NP-12-0028
July 13, 2012

Subject: Exelon Nuclear Texas Holdings, LLC
Victoria County Station
Early Site Permit Application
Environmental Report – Responses to ER RAI Letters No.12 and No.13
Docket No. 52-042

Exelon is responding to the following questions contained in NRC Request for Additional Information (RAI) letters No.12 (Reference 1) and No.13 (Reference 2):

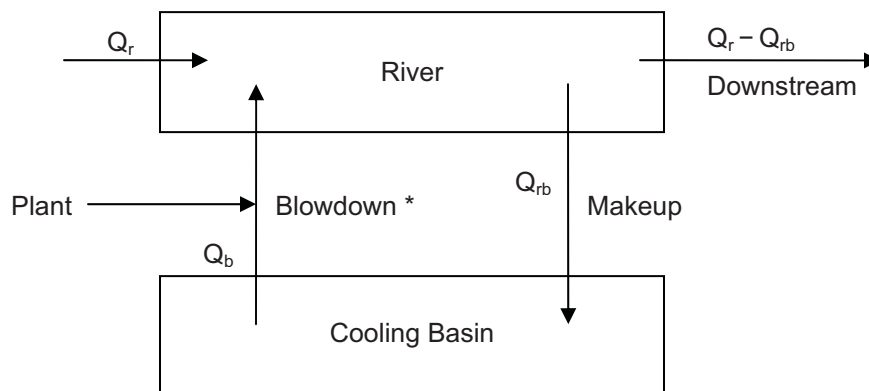
RW 3.5.-2 - ESRP Section 3.5 directs the staff to review the applicant's design of radioactive waste management and effluent control systems presented in the Environmental Report (ER). The blowdown discharge location for liquid effluent release is upstream of the raw water makeup intake structure (ER Figure 2.3.1-1). The releases upstream have a potential to get in the cooling basin through the raw water makeup system downstream. This mechanism could result in contaminating the cooling basin. ESRP Section 5.4.2 directs the staff to review the applicant's evaluation of doses due to radioactive gaseous and liquid effluent discharges presented in the ER. Licensees are responsible for evaluating any new exposure pathways and the resultant radiological hazards associated with the return of radioactive material to the operating facility and its subsequent discharge to the environment. As described in Regulatory Guide 1.109, "Calculation of Annual Doses to Man from Routine Releases of Reactor Effluents for the Purpose of Evaluating Compliance with 10 CFR Part 50, Appendix I, "Revision 1, issued October 1977, licensees must evaluate any new exposure pathways to members of the public that contribute 10 percent or more of the total effluent dose and include these dose assessments in their demonstration of compliance with Appendix I to 10 CFR Part 50 Agencywide Documents Access and Management System at Accession No. ML072120368. Provide an evaluation of the potential radioactivity buildup concentration (pCi/L) in the cooling basin from the operation of proposed VCS units. Additionally, based on the radioactivity buildup concentration in the cooling basin, provide estimate of dose impacts to different receptors.

Liquid effluent from the proposed facility is to be discharged into the Guadalupe River via the cooling basin blowdown line. Downstream of the discharge point, a fraction of the river water is diverted to the plant as makeup for the cooling basin. As indicated in Regulatory Guide 1.113, for large water volumes with small blowdown rates, the concentrations of long-lived isotopes may build up over a period of several years [Ref 1, Sheet 37].

Equation 4 indicates that the concentration in the cooling basin may be conservatively estimated by multiplying the concentration in the river by the ratio of makeup rate to removal rate. The normal flow rates in the cooling basin are as follows, conservatively neglecting precipitation and losses via cooling towers [ER Figure 3.3-2]:

The maximum instantaneous makeup water flow from the river to the cooling basin is 97,396 gpm [ER Figure 3.3-2] or 217 cfs. Based on daily statistics from 1935 to 2008, the mean river flow rate is 2001 cfs [Reference 2]. Therefore, approximately 11% of the historical mean river flow may be diverted to the cooling basin, where there is potential for concentration buildup before being returned to the river via the blowdown pathway.

It is concluded that the impact of cooling basin recirculation on long-lived isotopes in the river and the resulting doses at liquid effluent receptors is negligible in light of the conservatism in the assumed river flow rate. Table 5.4-1 will be revised to clarify this conservatism. Furthermore, the liquid effluent source terms are based on a conservative composite of multiple reactor designs.
